AGENDA
DANIA BEACH CITY COMMISSION
REGULAR MEETING
TUESDAY, AUGUST 23, 2016 - 7:00 PM

A RESOLUTION OF THE CITY COMMISSION OF THE CITY OF DANIA BEACH, FLORIDA, APPROVING THE SITE PLAN (SP-75-15) AND DESIGN VARIATIONS (OT-64-16) AND (OT-82-16) SUBMITTED BY DAVID L. WALLACE & ASSOCIATES, INC. ON BEHALF OF THE OWNER, ALEXEY SHCHETNIKOV, FOR PROPERTY LOCATED AT 321 NORTH FEDERAL HIGHWAY IN THE CITY OF DANIA BEACH, FLORIDA; PROVIDING FOR CONFLICTS; FURTHER, PROVIDING FOR AN EFFECTIVE DATE.

5 Dumpster Plan View
AS-03 SCALE: 1/4" = 1'-0"

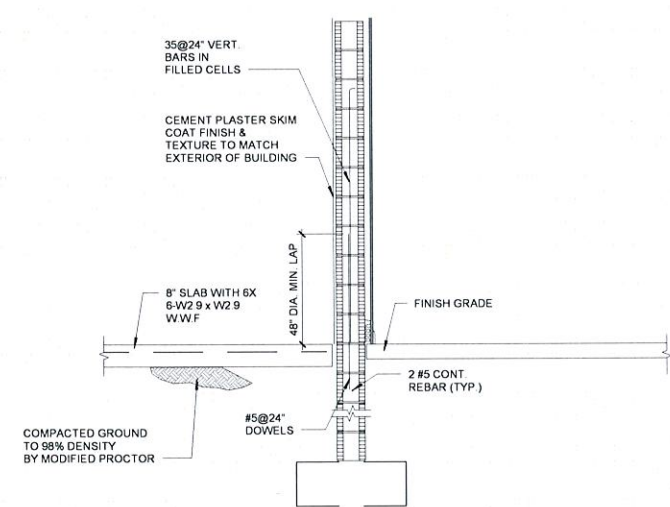
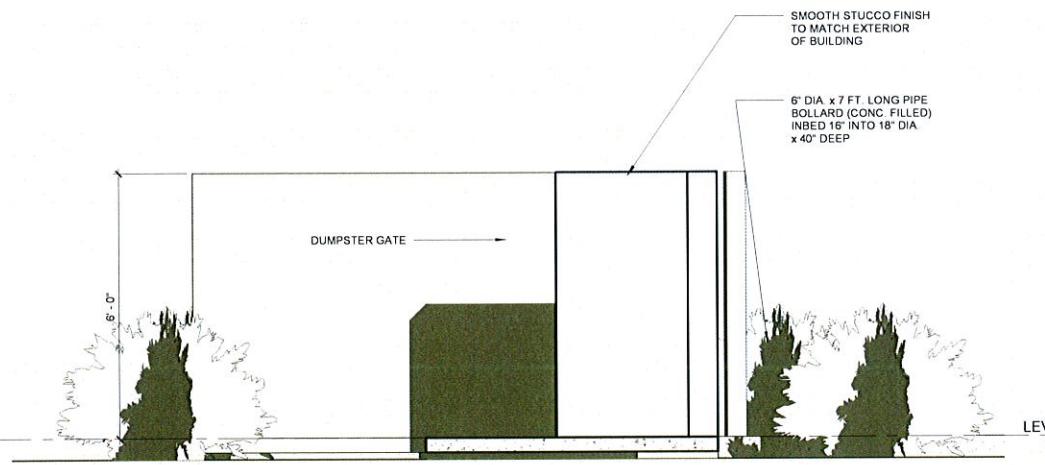
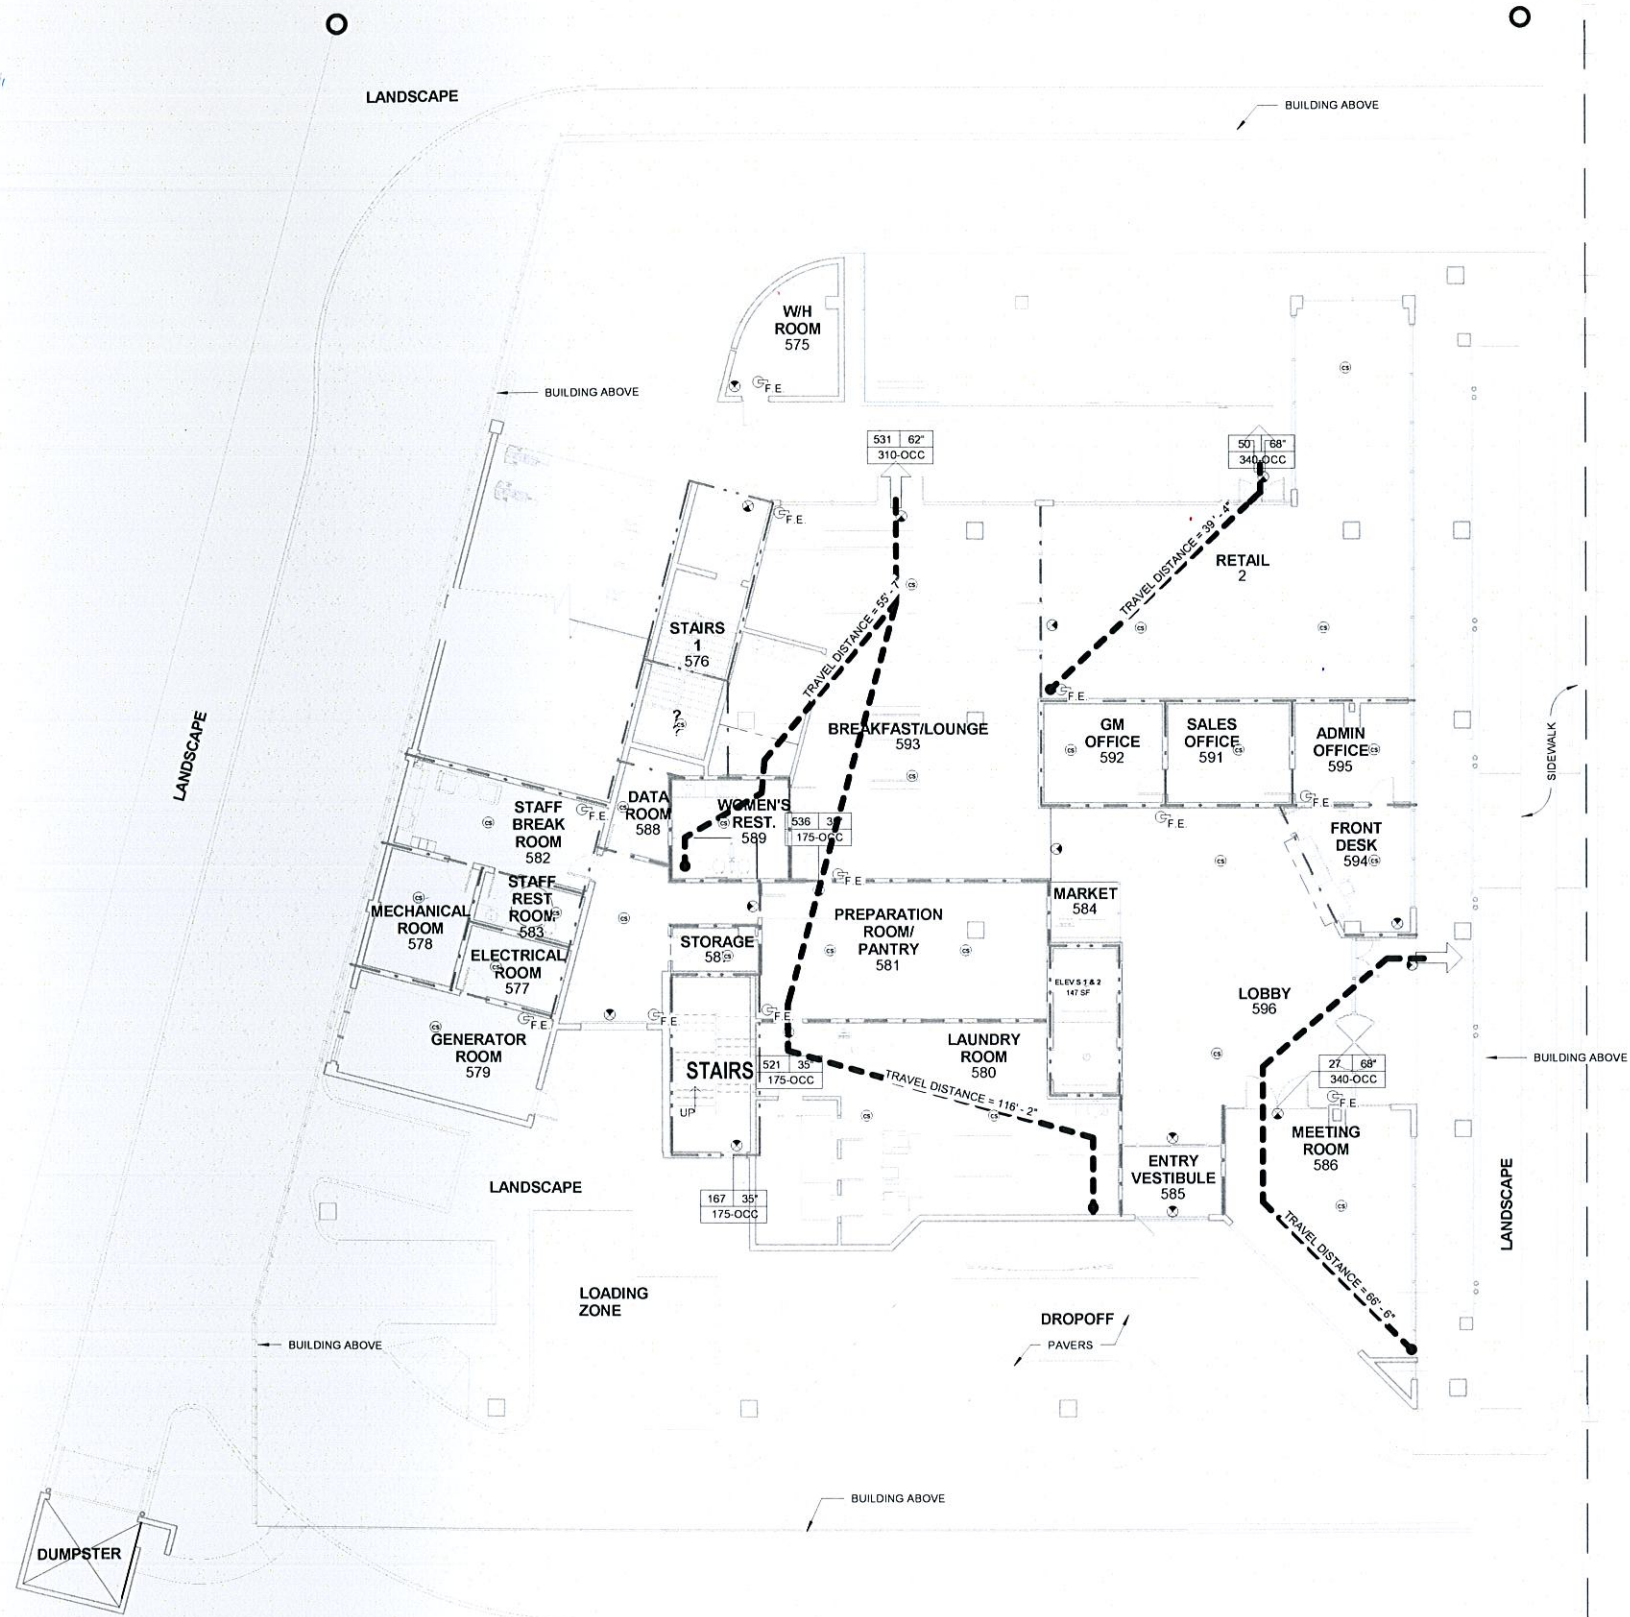
The maze is not shown on Site Plan, Sheet AS.01

RESPONSE: DUMPSTER ENCLOSURE DETAILS HAVE BEEN REVISED TO PROVIDE MAZE-STYLE ENTRY. SEE REVISED SHEET AS-03 AND SITE PLAN AS-01.

ROOF
 SCALE: 3/32" = 1'-0"

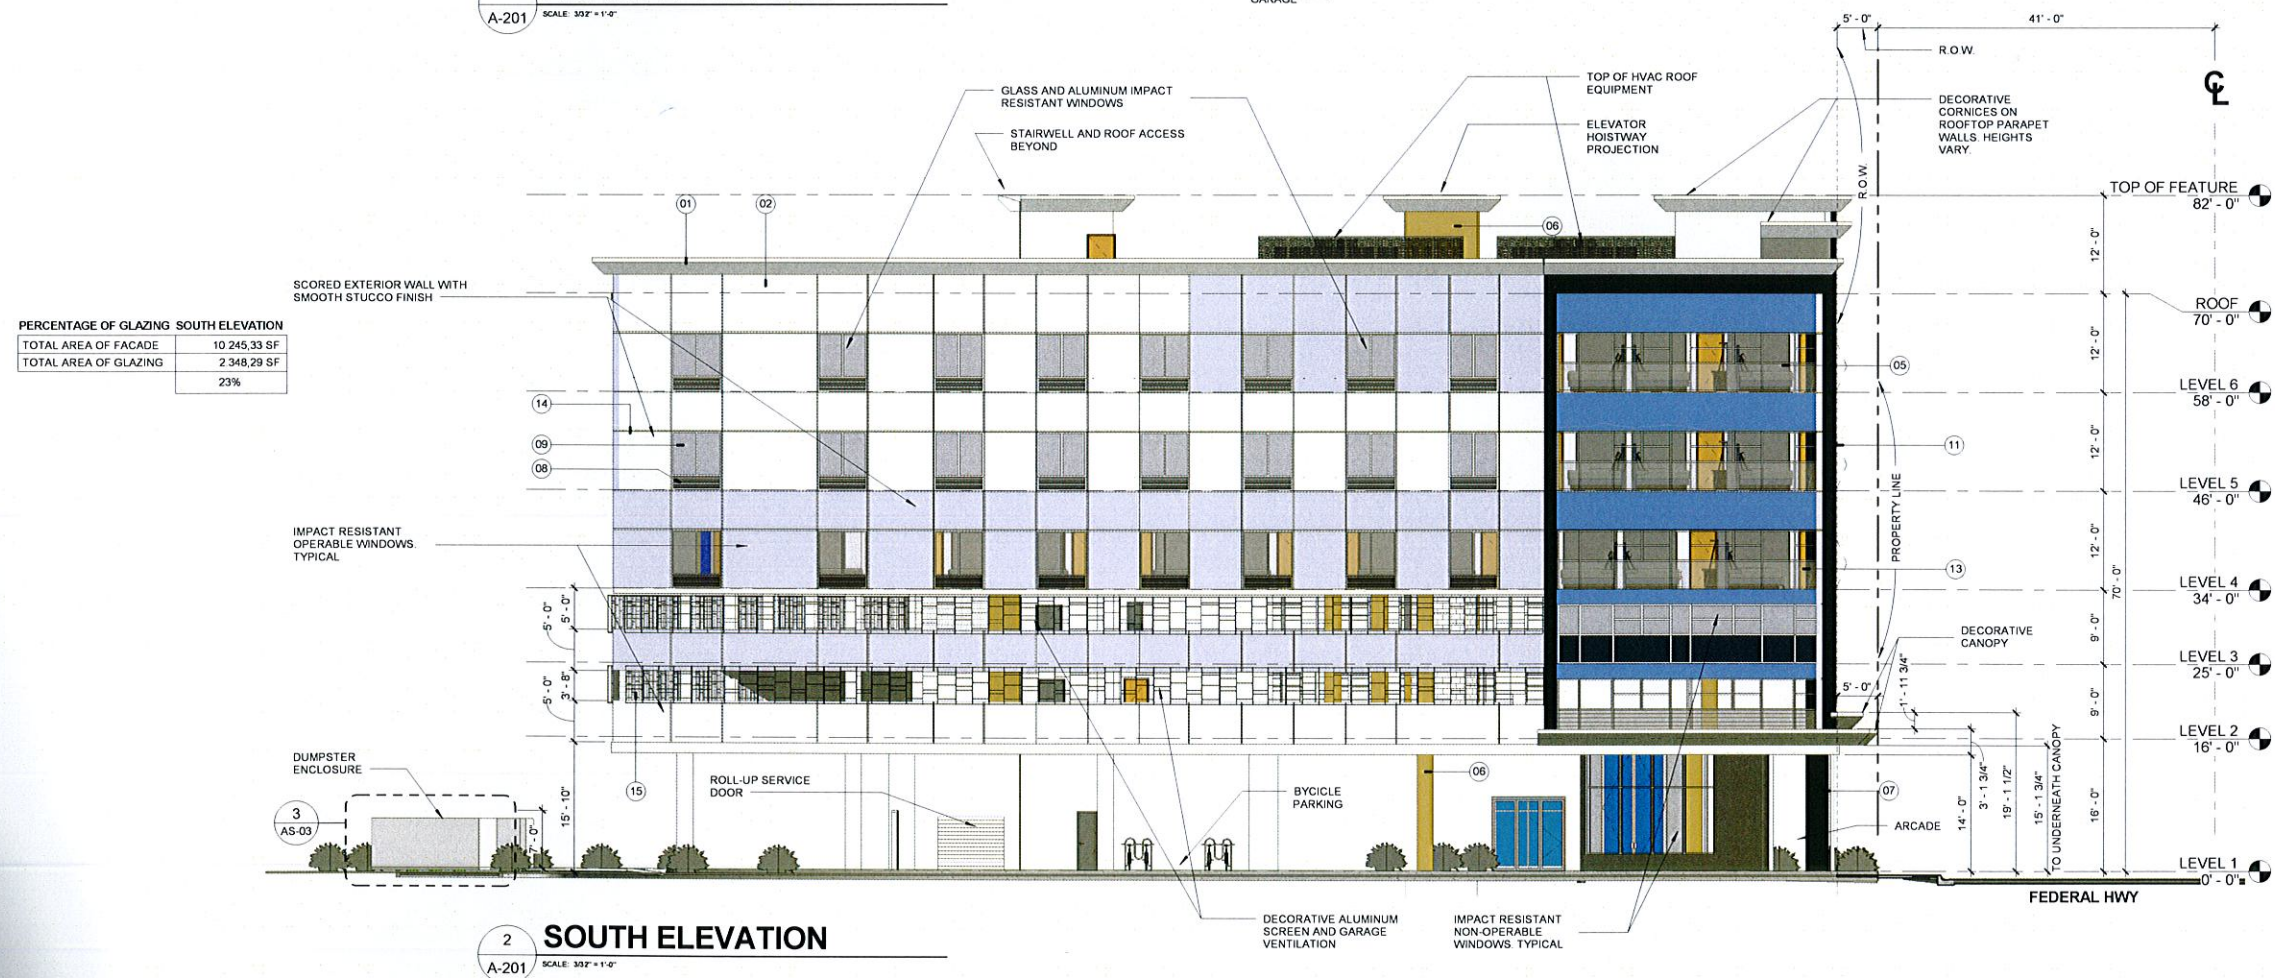
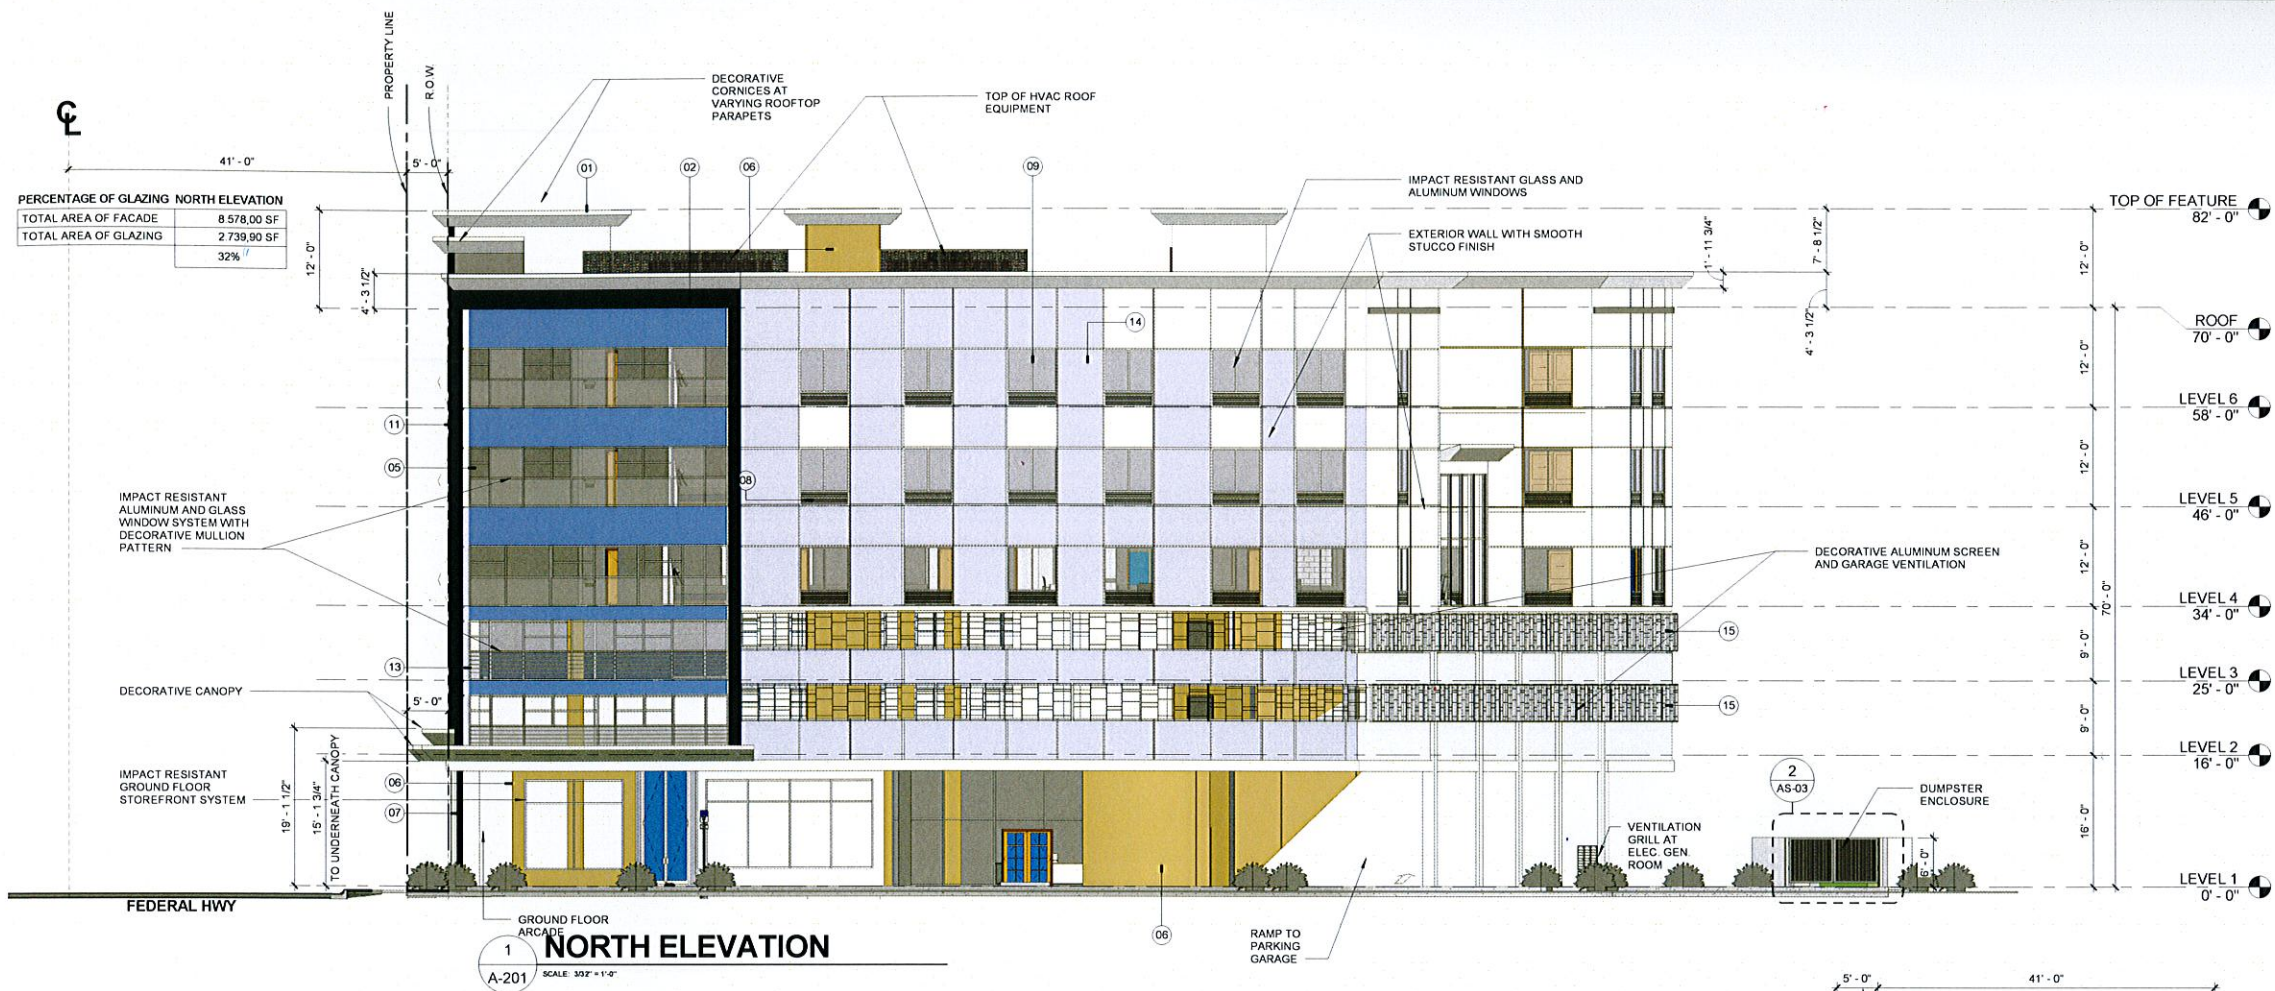
38. Per Section 525-20(G) all rooftop mechanical equipment/stairs/elevator shall be designed to be an integral part of the building or shall be adequately screened and shall not exceed 12' in vertical height and not to exceed 20% of roof top. Identify how this provision is being met on the plans. 2nd time requested. Sheet A-200 & A-201 appear to show HVAC roof equipment visible from all elevations. Revise according.

RESPONSE: REFER TO ROOF PLAN INDICATING LOCATION OF AC EQUIPMENT ON FLAT ROOF ALONG WITH THE VARYING HEIGHTS OF THE ROOF PARAPET WHICH ALSO SERVE TO PROVIDE SCREENING OF THE EQUIPMENT FROM VISIBILITY. THE ROOFTOP EQUIPMENT IS LOCATED TOWARDS THE INTERIOR OF THE ROOF SPACE AWAY FROM THE BUILDING EXTERIOR AND THEREFORE WOULD NOT BE VISIBLE FROM THE EXTERIOR DUE TO THE SURROUNDING PARAPET WALLS AND VANTAGE POINT NEEDED. SHEET A-201 IS AN ORTHOGONAL ELEVATION VIEW AND NOT REPRESENTATIVE OF HOW IT WOULD BE SEEN IN PERSPECTIVE.

1
A-202
Hotel Signage at East Facade
1/4" = 1'-0"

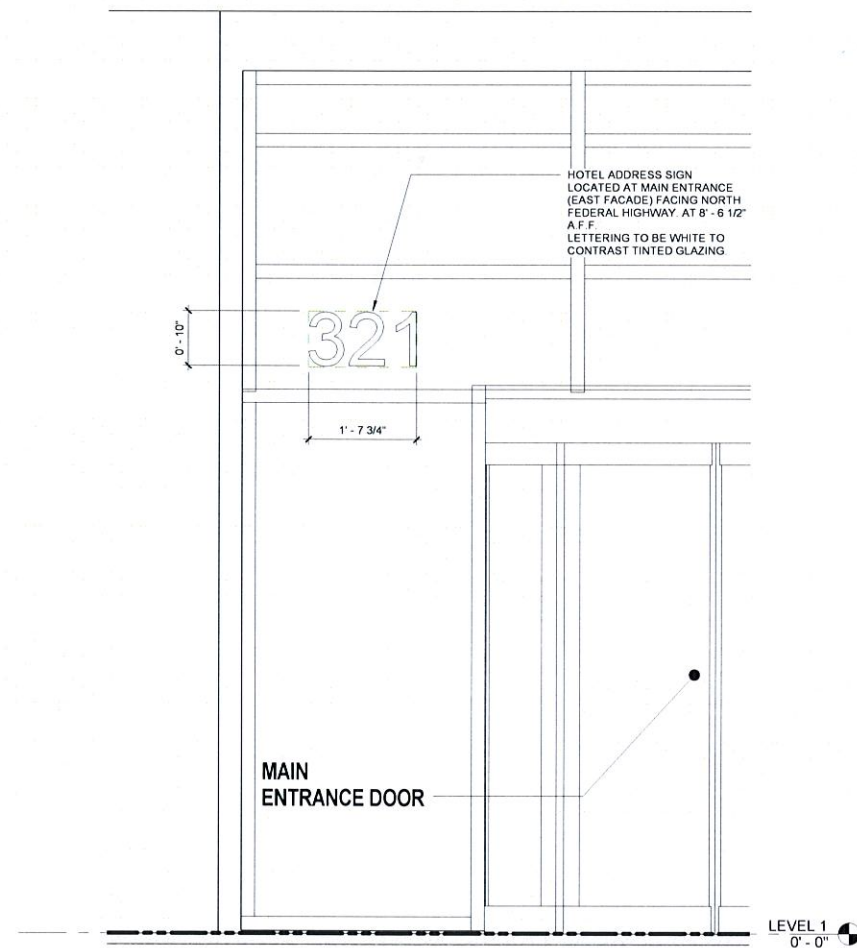
- Raceways shall be placed inside the building wall or shall be painted the color of the sign background. Provide detail.
- Per Section 505-40(O)(5) cabinet signs are prohibited.
- **RESPONSE:** CLARIFICATIONS REGARDING FONT AND COLOR HAVE BEEN INCORPORATED INTO THE REVISED SHEET A-202. WE ARE CURRENTLY NOT AWARE OF ANY OTHER ITEMS THAT HAVE NOT BEEN ADDRESSED IN THE ABOVE COMMENT. IF SO, PLEASE ADVISE. (SEE REVISED SHT. A-202)

- **RESPONSE:** CLARIFICATIONS REGARDING FONT AND COLOR HAVE BEEN INCORPORATED INTO THE REVISED SHEET A-202. WE ARE CURRENTLY NOT AWARE OF ANY OTHER ITEMS THAT HAVE NOT BEEN ADDRESSED IN THE ABOVE COMMENT. IF SO, PLEASE ADVISE. (SEE REVISED SHT. A-202)
